**COMMISSION ORDER ADOPTING THE SETTLEMENT AGREEMENT
 AMONG THE PARTIES TO THE COMPLAINT AGAINST THE EL
 SEGUNDO ENERGY CENTER**

Joint Statement of Agreement

PROPOSED SOUTH SLOPE:
301 VISTA DEL MAR BOULEVARD
EL SEGUNDO ENERGY CENTER
 CITY OF EL SEGUNDO COUNTY OF LOS ANGELES STATE OF CALIFORNIA

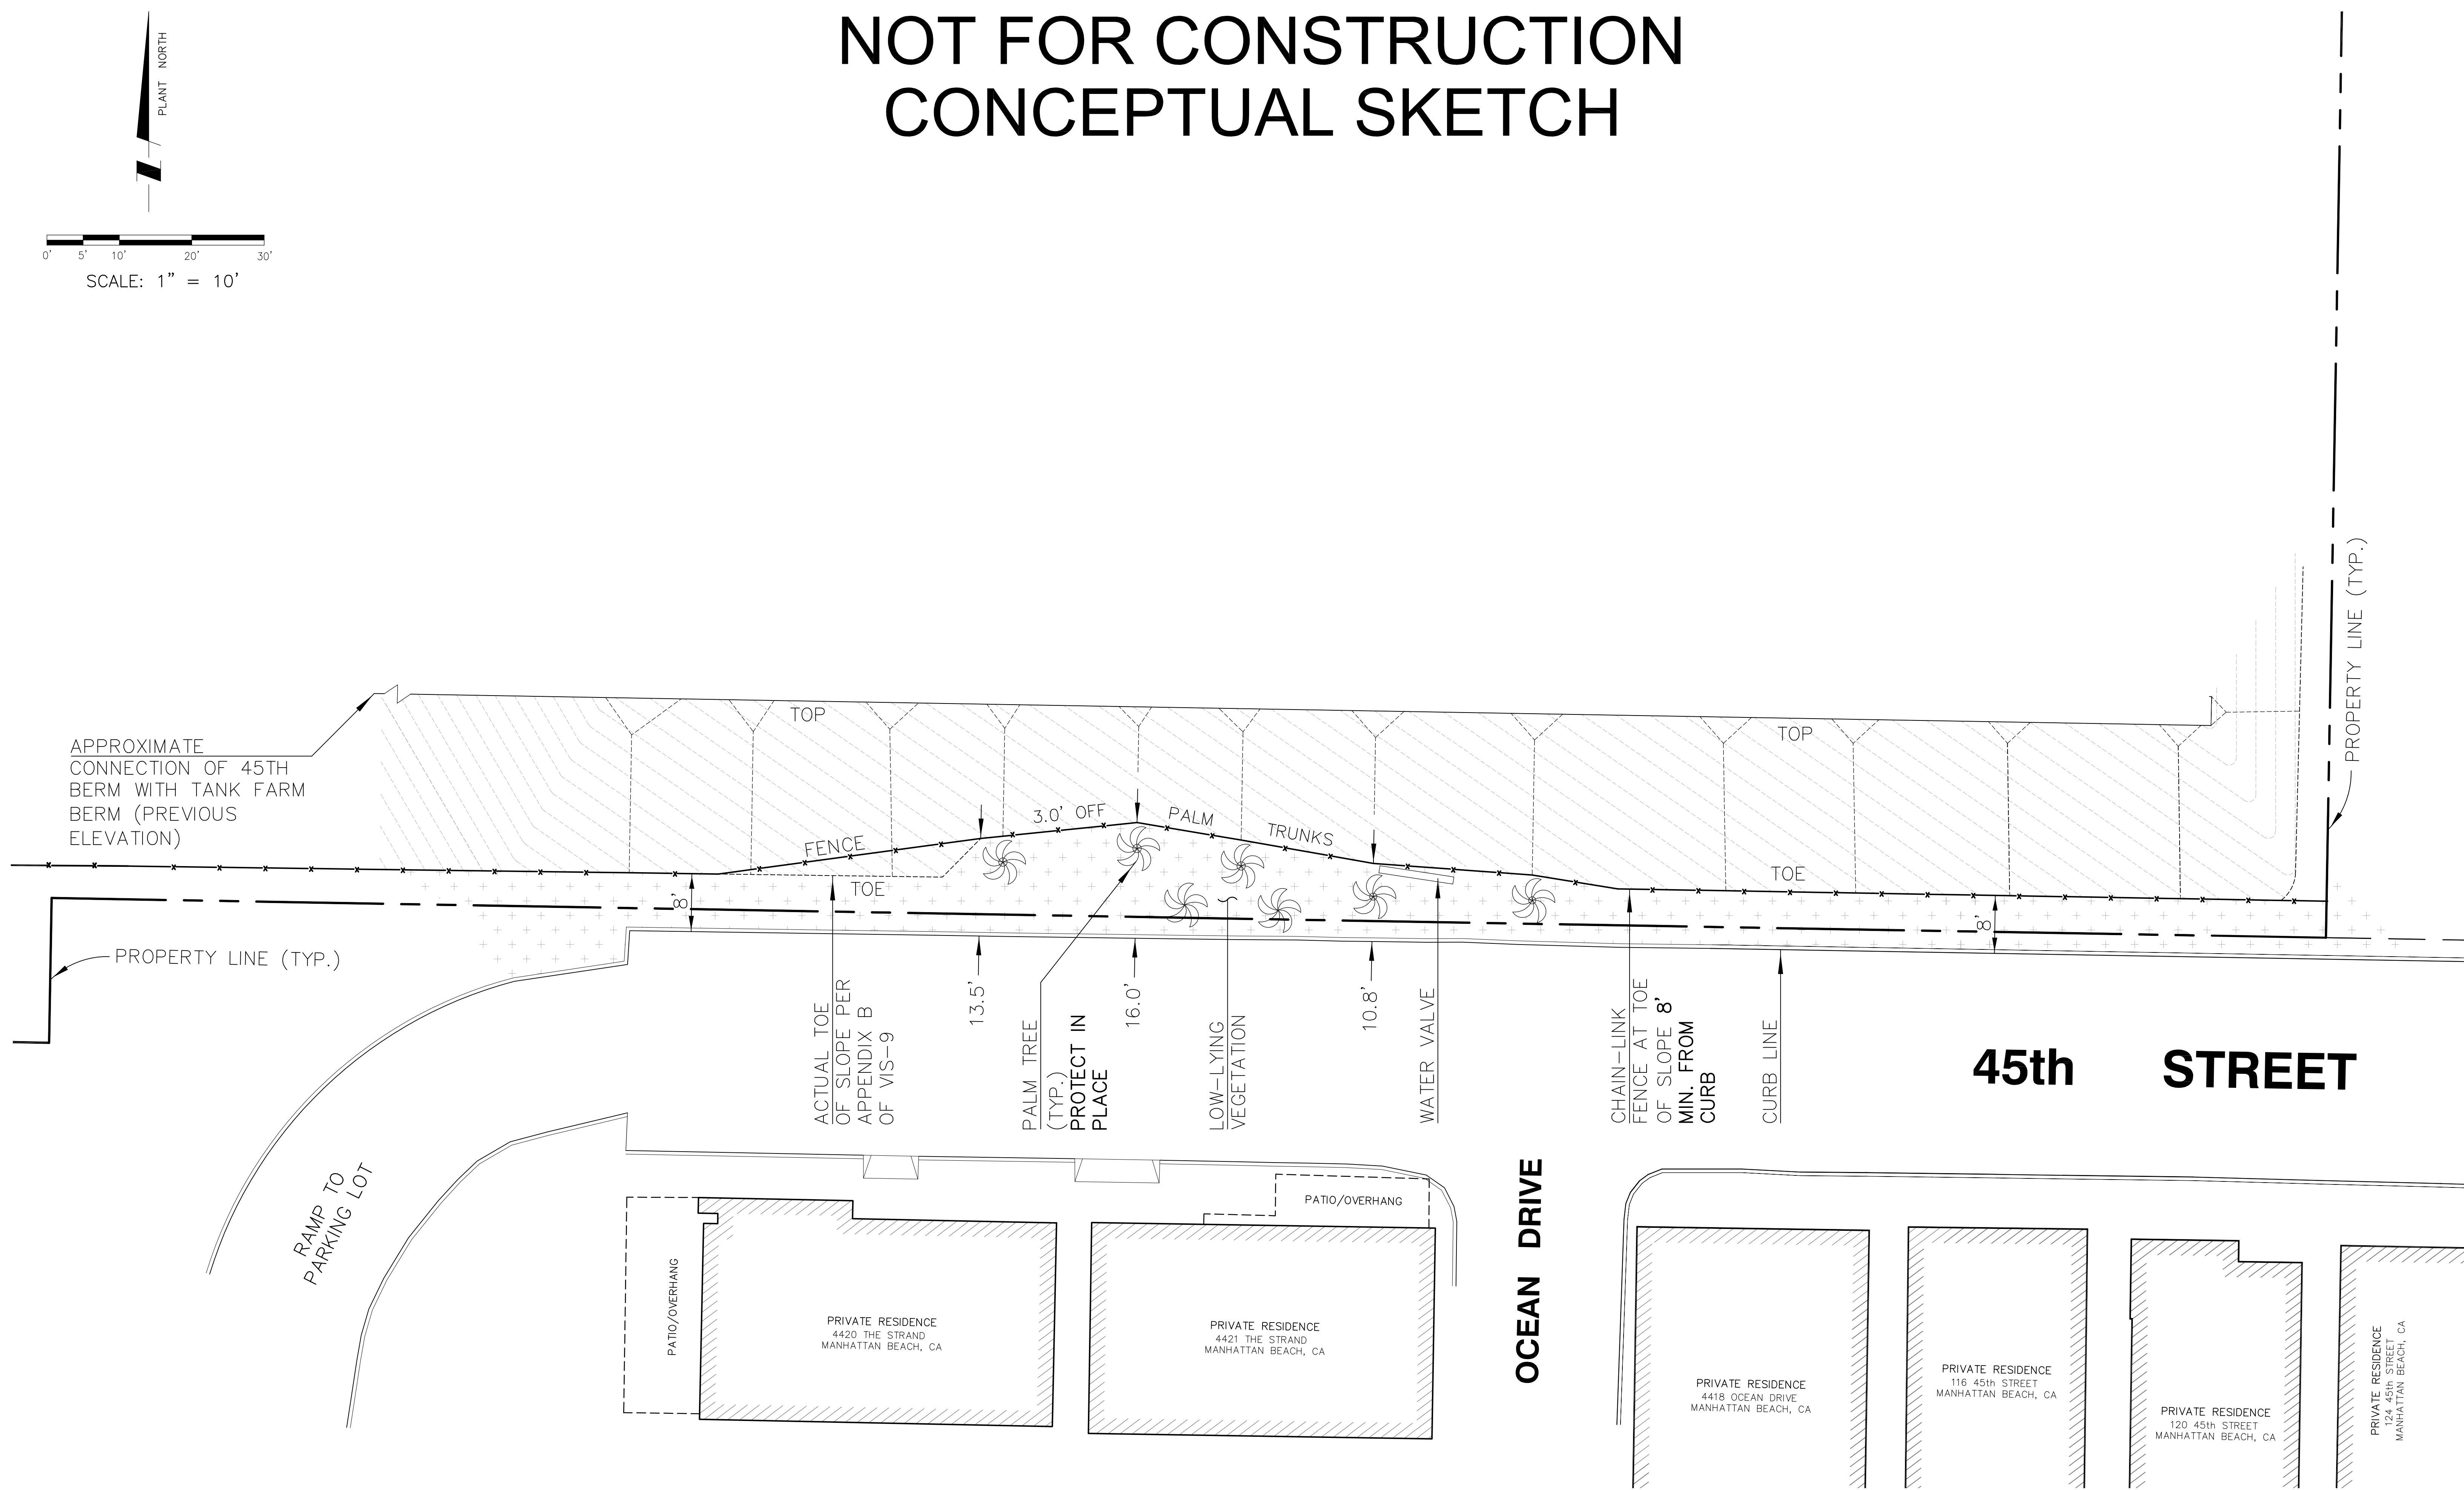
- a. The Parties jointly agree that the steepness of slope of the new 45th Street berm shall be increased in the area of the existing potable water valve and existing palm trees so the toe of the slope do not reach the trees and that the existing palm trees shall be retained and incorporated into the landscaping. A general depiction of intended location of the toe of the slope is provided in Attachment A to this document.

similar to historic fence location. The Parties recognize that the exact location of the fence was never strictly decided in the past and that documents differed on its location. The Parties also acknowledge that a temporary fence on the southern property line is necessary during construction of the southern area landscaping features but that it will be replaced with the permanent fence promptly upon completion of the landscaping along the southern perimeter. A general depiction of the intended location of the fence is provided in Attachment A to this document.

- 5) ESECL agrees to prepare and submit to the City of Manhattan Beach, the City of El Segundo and the Parties for comment and then to the Compliance Project Manager (CPM) for approval, a revised 45th Street Berm Drawing (Appendix B to the ***Temporary Landscaping and 45th St. Berm – Vis-9*** landscaping plan) that reflects the increased slope steepness to pull the slope back from the existing palm trees. The drawing should be consistent with the sketch provided as Attachment A.
